**FINAL DRAINAGE REPORT
FOR
ESTATES AT CATHEDRAL PINES,
EL PASO COUNTY, COLORADO**

October 2023

JR ENGINEERING
5475 Tech Center Drive
Colorado Springs, CO 80919
(719) 593-2593

DPO3 - 100-YEAR

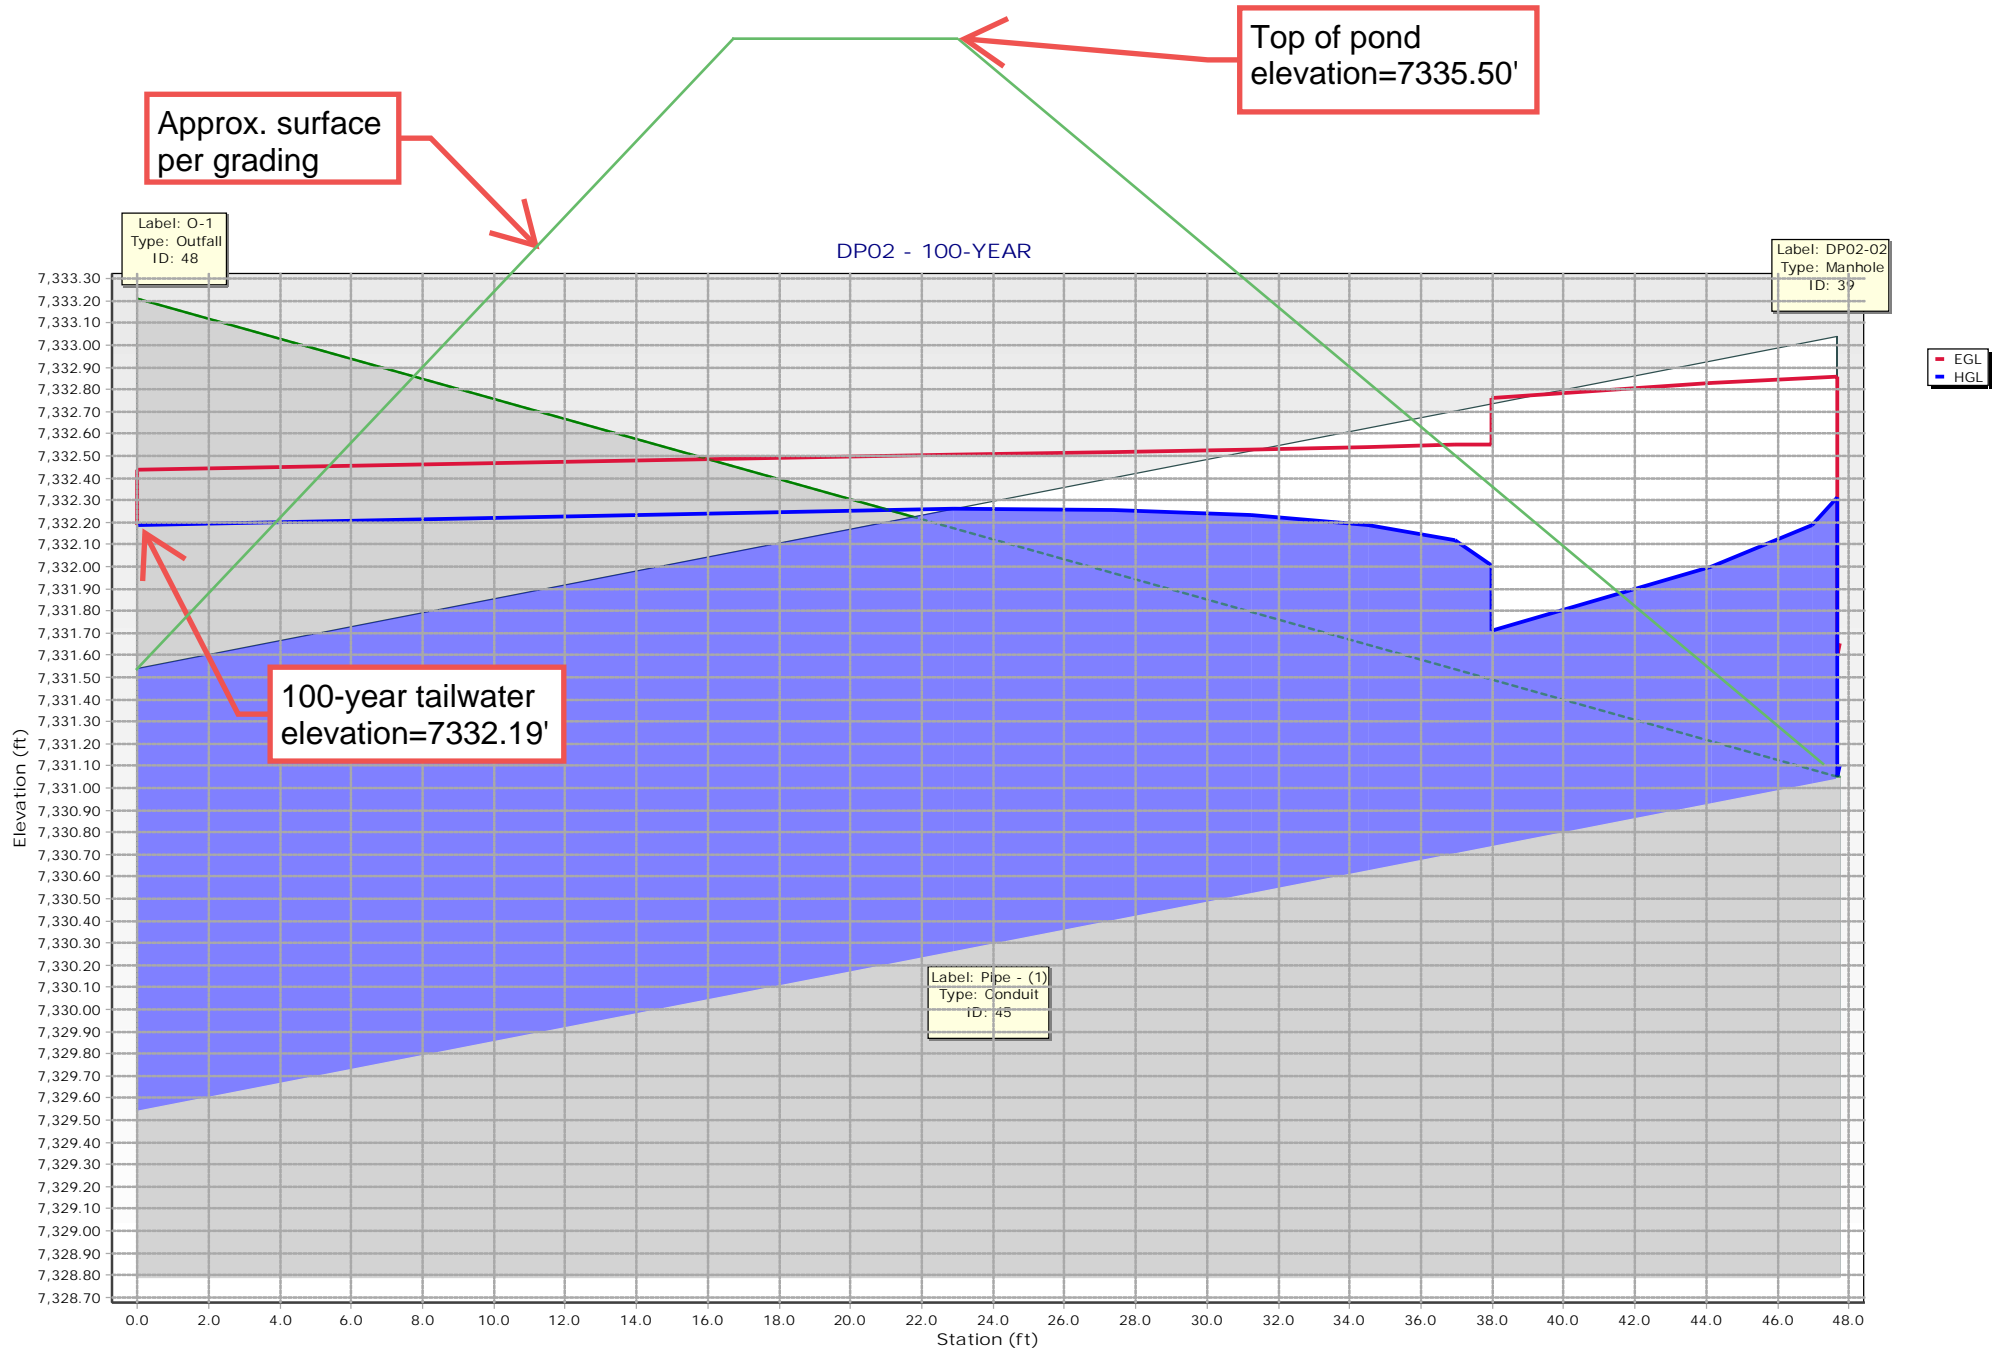
For DP3 and 5 - tailwater does not appear to be modeled based on the HGLs shown on the profiles. Verify. Tailwater for those outfalls should be normal depth in the downstream ditches.

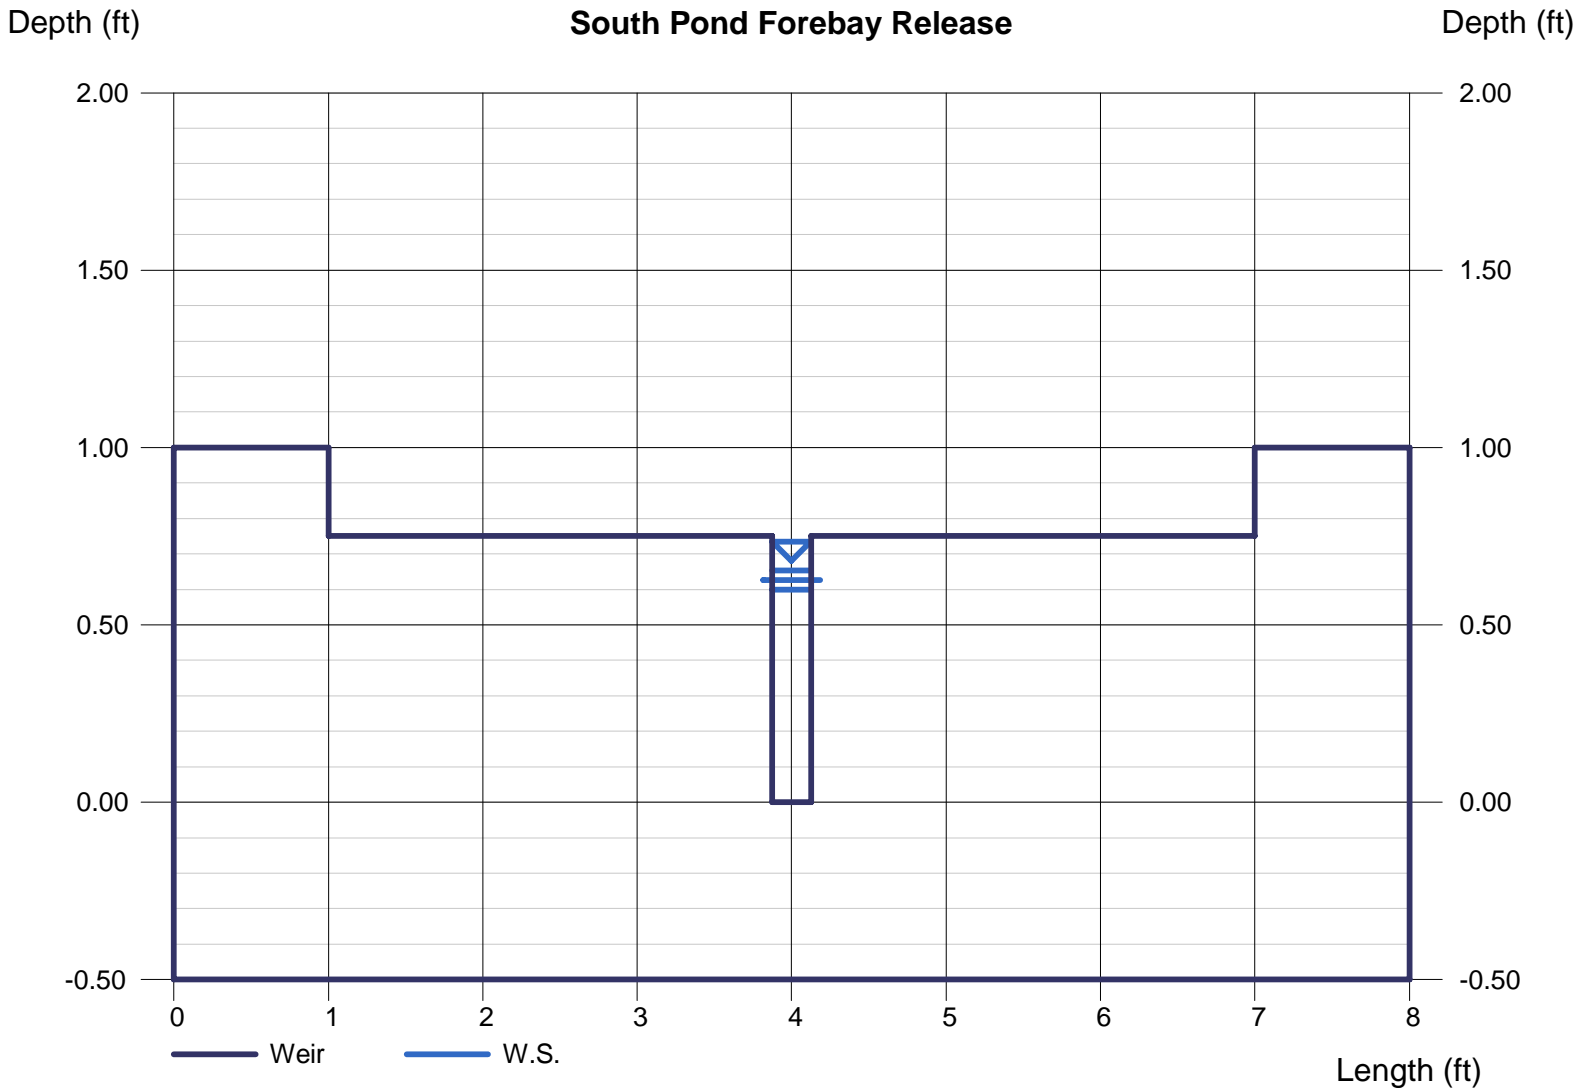
4" per the previous forebay calculations

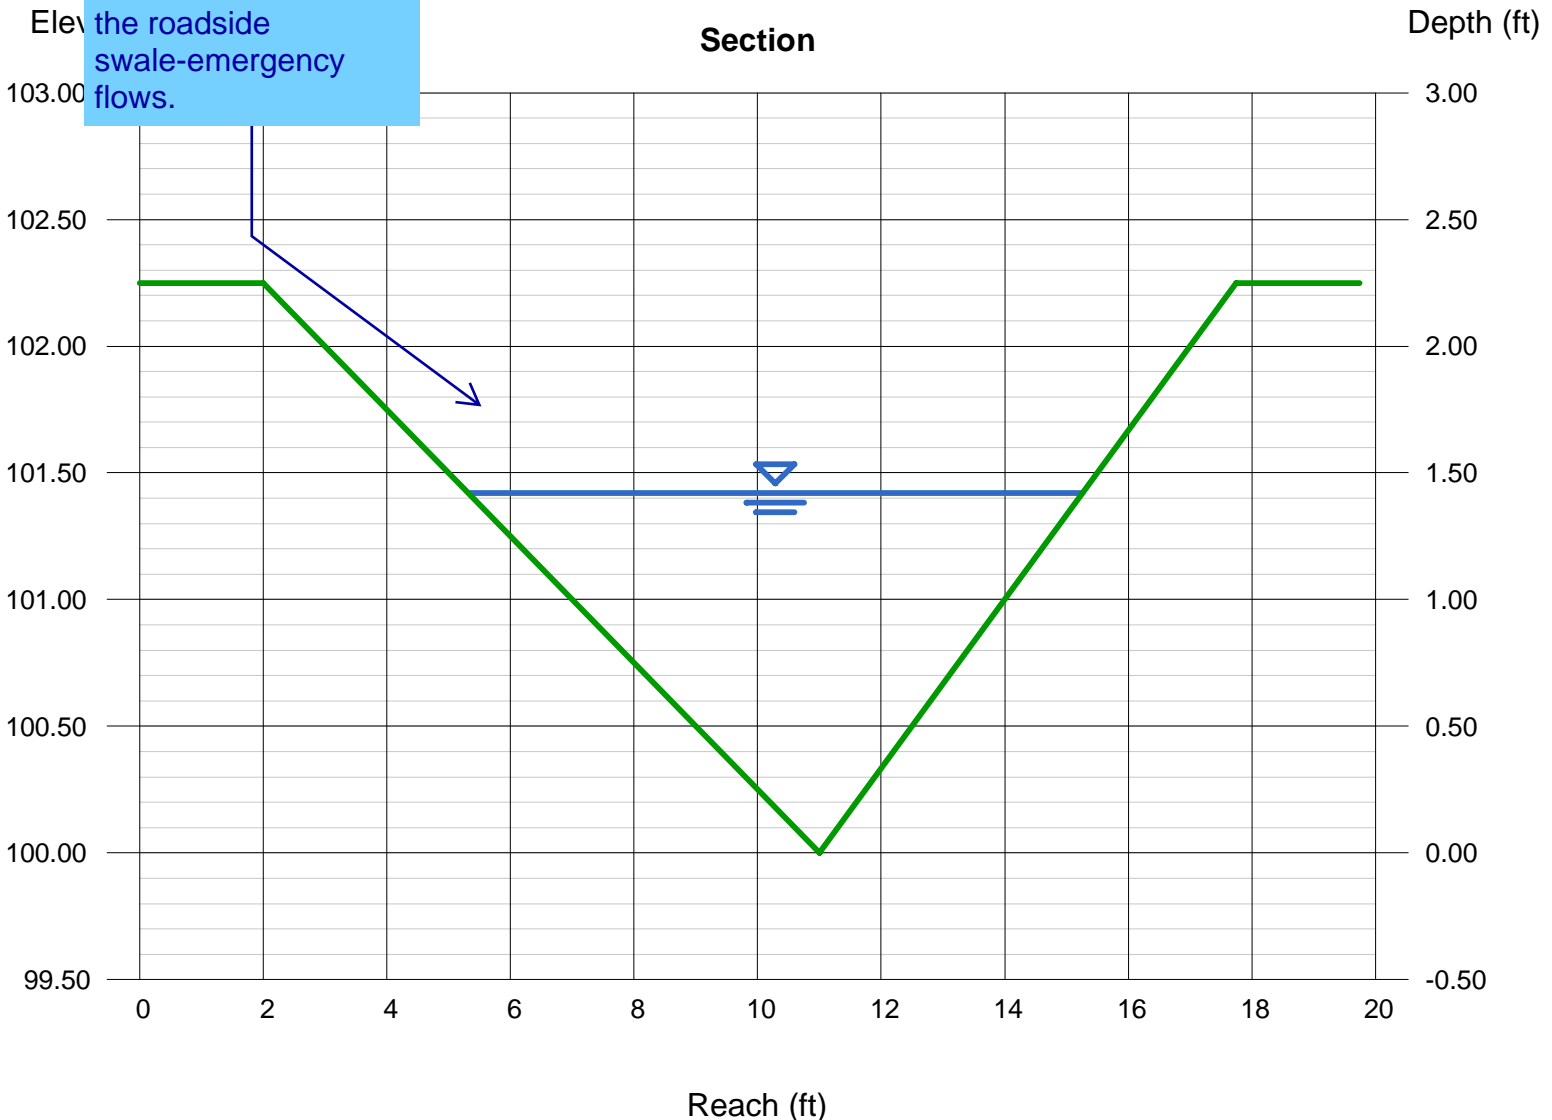
Please provide erosion protection for this swale as velocity is above the standard velocity per DCM vol.1, chapter 10, table 10-4

Please provide at least 1ft freeboard for the roadside swale-emergency flows.

EXISTING DRAINAGE MAP
CATHEDRAL PINES
JOB NO. 25260.00
09/15/2023
SHEET 1 OF 1

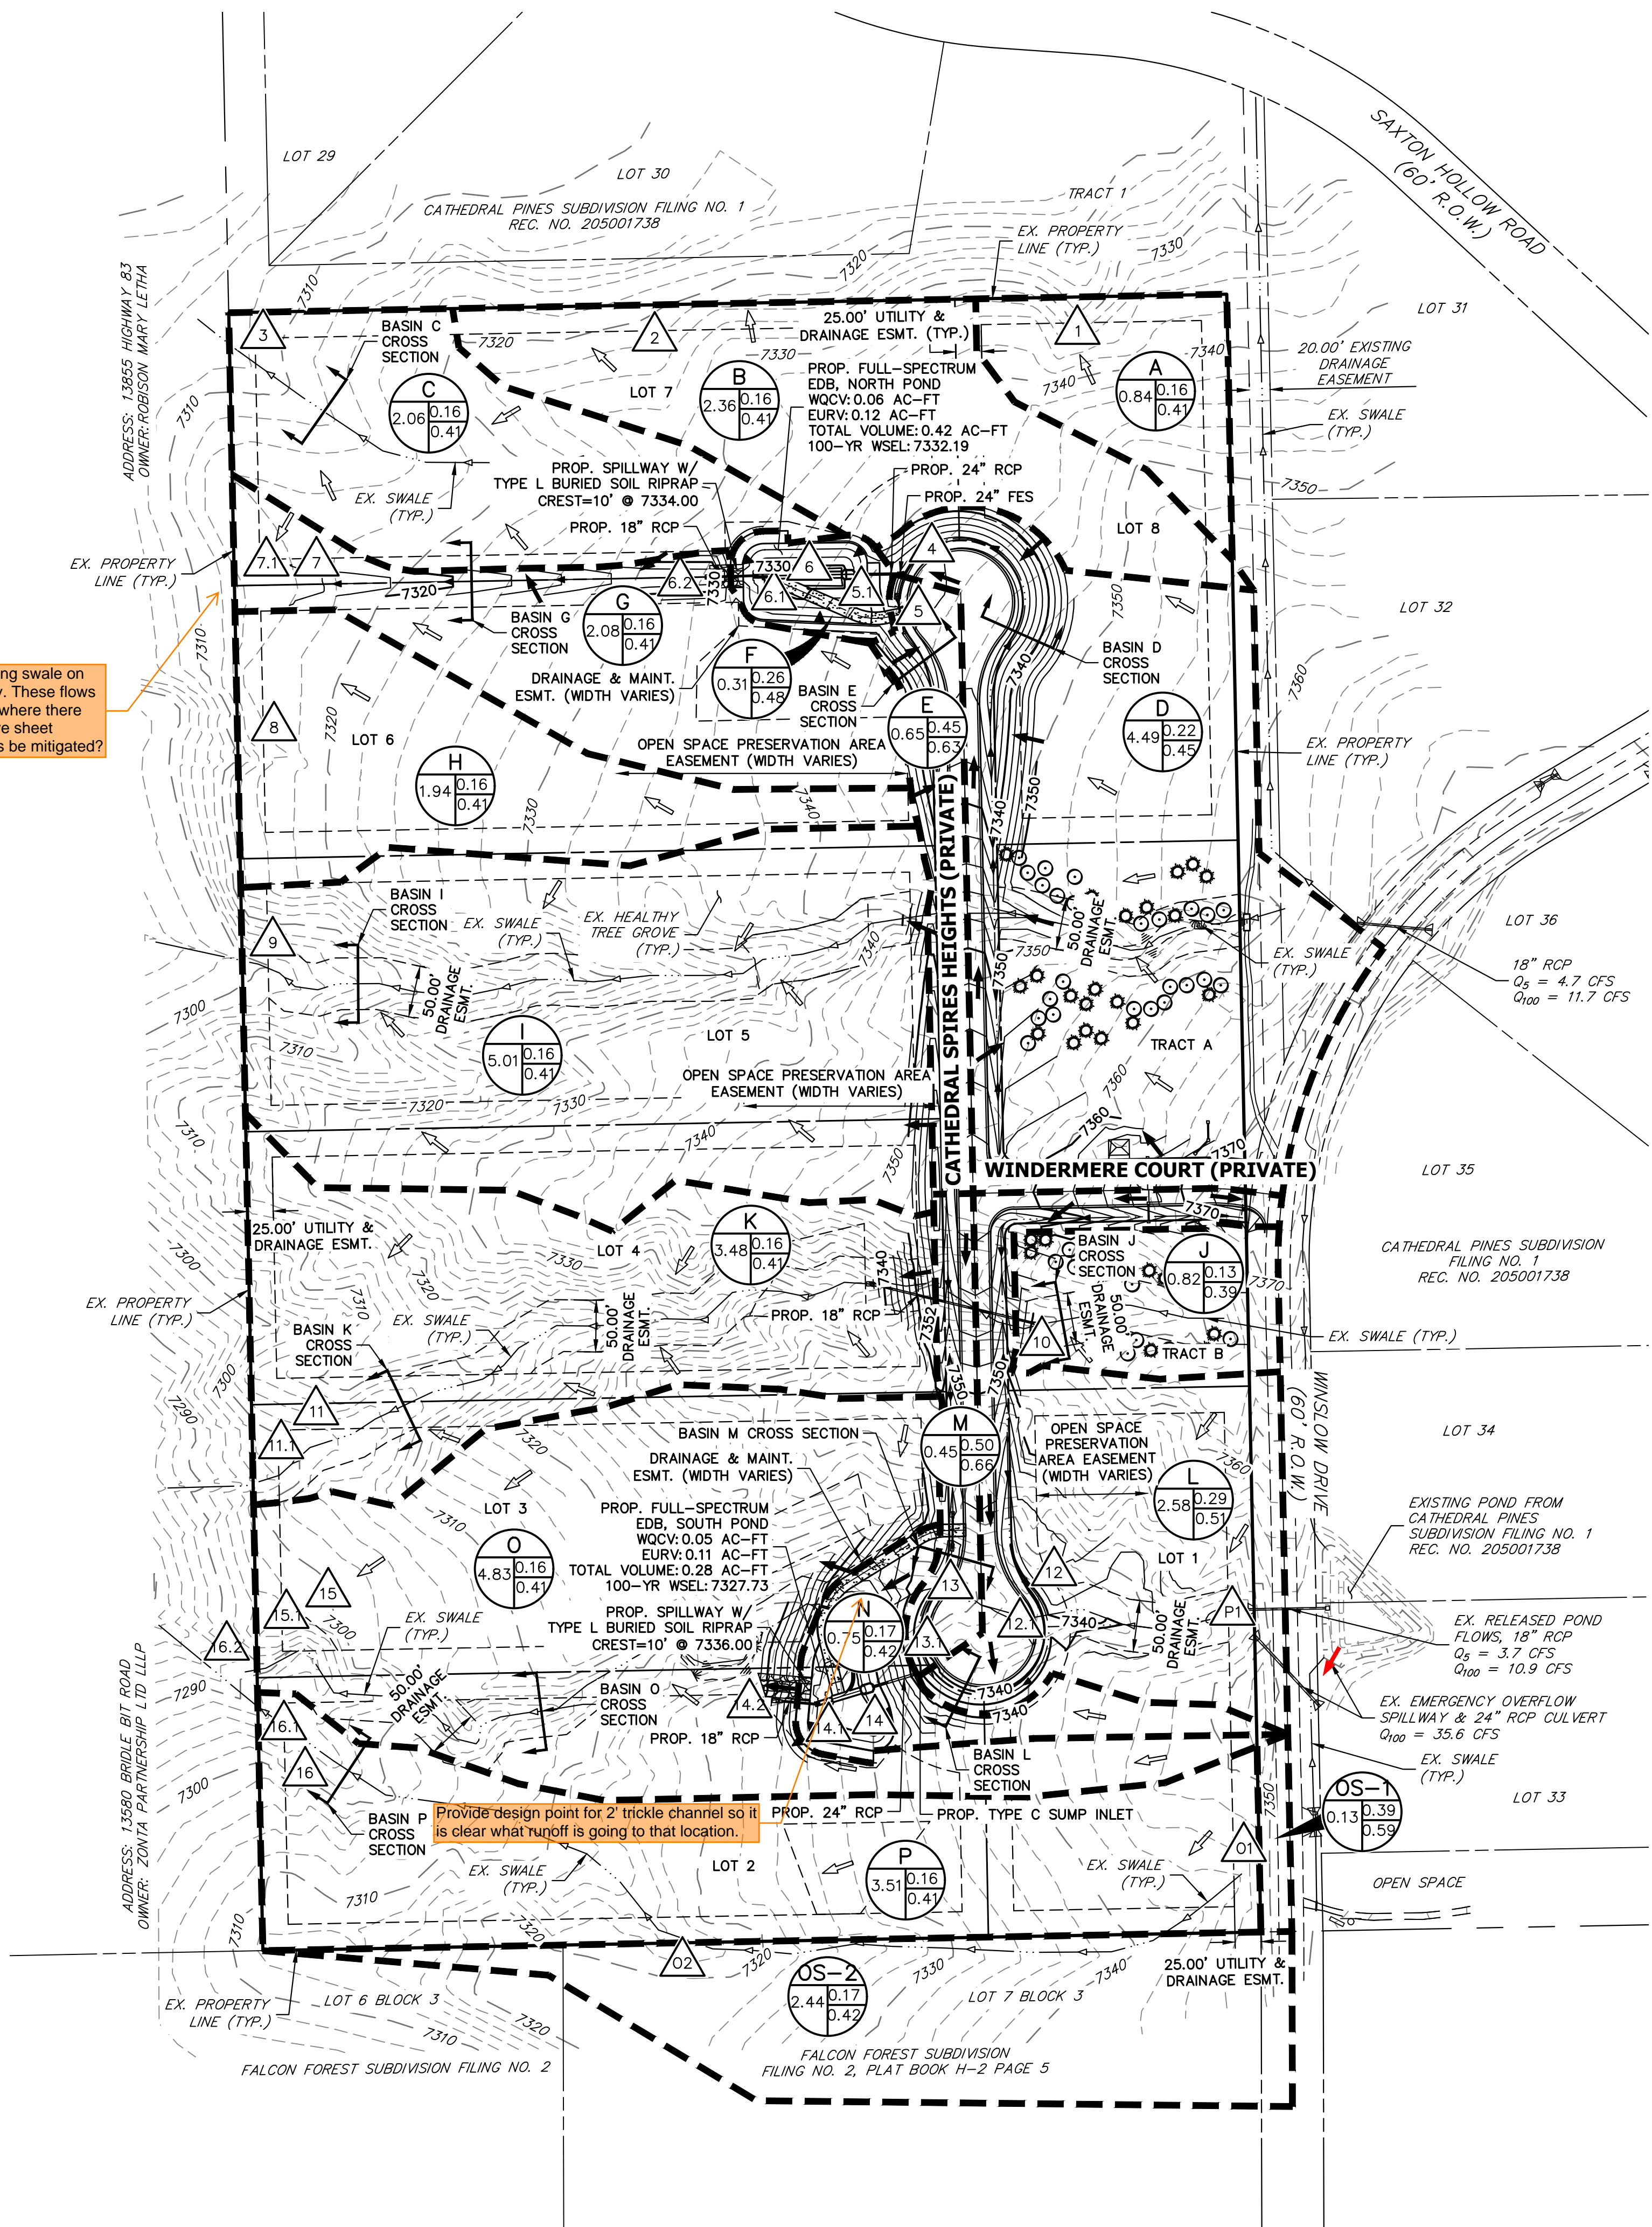
There is not an existing swale on the adjacent property. These flows will be concentrated where there previously would have sheet showed. How will this be mitigated?

Provide design point for 2" trickle channel so it is clear what runoff is going to that location.
